Yester Jeans Ltd.

Plot # 111-114, Adamjee EPZ, Siddhirgonj, Narayangonj.
(23.674005 N, 90.529693 E)

28 February 2015

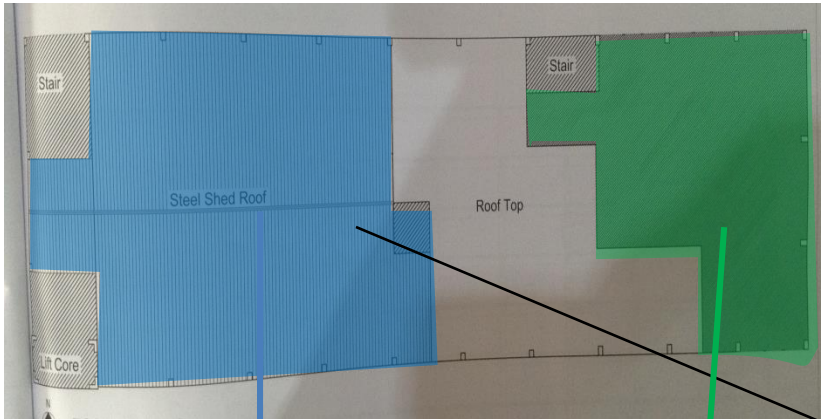
Discrepancies between Permit drawings and the as-constructed arrangement of the factory

Item No.	Observation	Recommended Action Plan	Recommended Timeline
10	Discrepancies between permit drawing, design drawings and as built structure	Building Engineer to commence an update of the drawings to reflect the as-built structure and loading levels at all floor levels, including as built floor finishes thickness.	6-weeks
11	Discrepancies between permit drawing, design drawings and as built structure	The steel roof design drawings to be attached to the As-built drawings and the structure of the roof to be confirmed as being adequate to withstand horizontal and vertical loadings as per code.	6-weeks
12	Heavily loaded areas	Building Engineer to confirm design loading of slabs and incorporate it into the loading plan for all floor plates within the Building.	6-weeks
13	Heavily loaded areas	Produce a loading plan and actively manage the floor loading for all floor plates within the Building giving consideration to floor capacity and column capacity.	6-weeks

Permit drawing - elevation

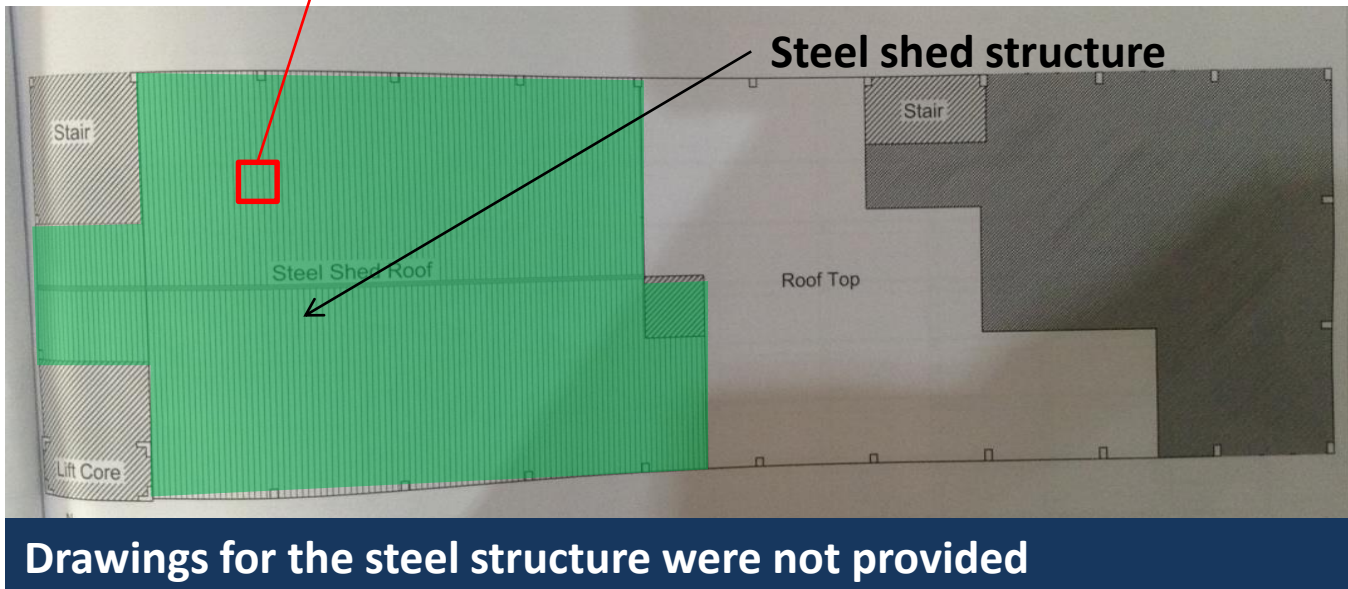
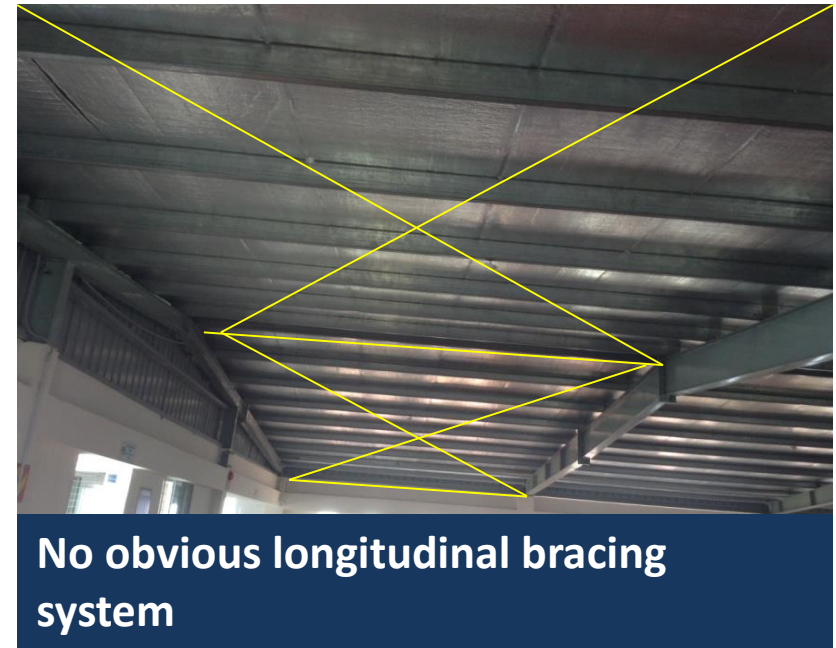
Steel structure not on permit drawing

Heavily loaded areas

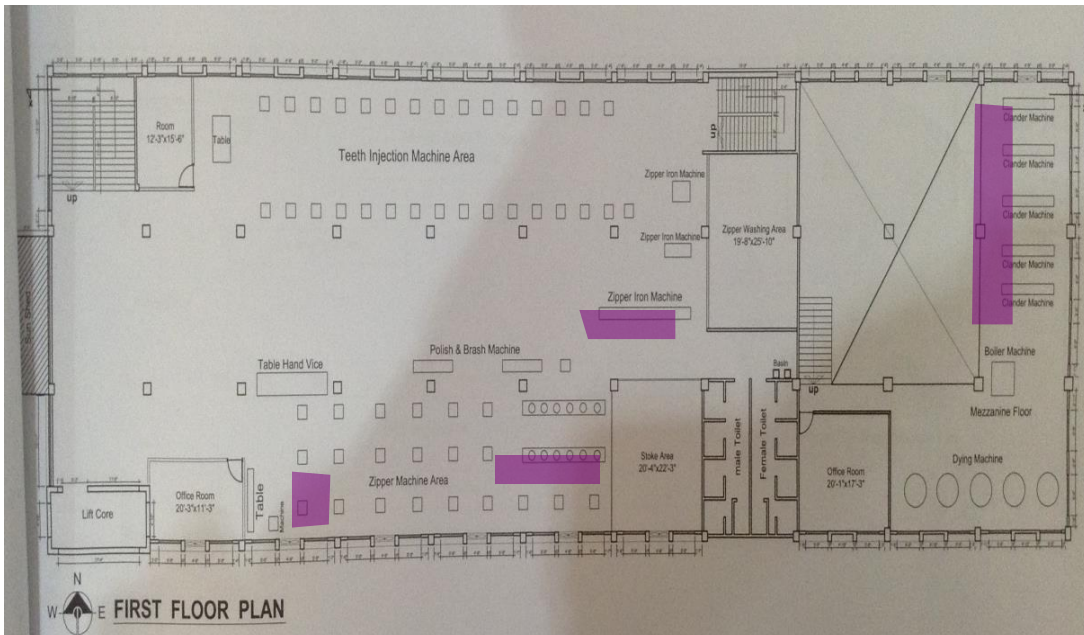
1st floor- machine loads
Technical information on the machines was not provided

14	Heavily loaded areas	Continue to implement the load management plan	6-months
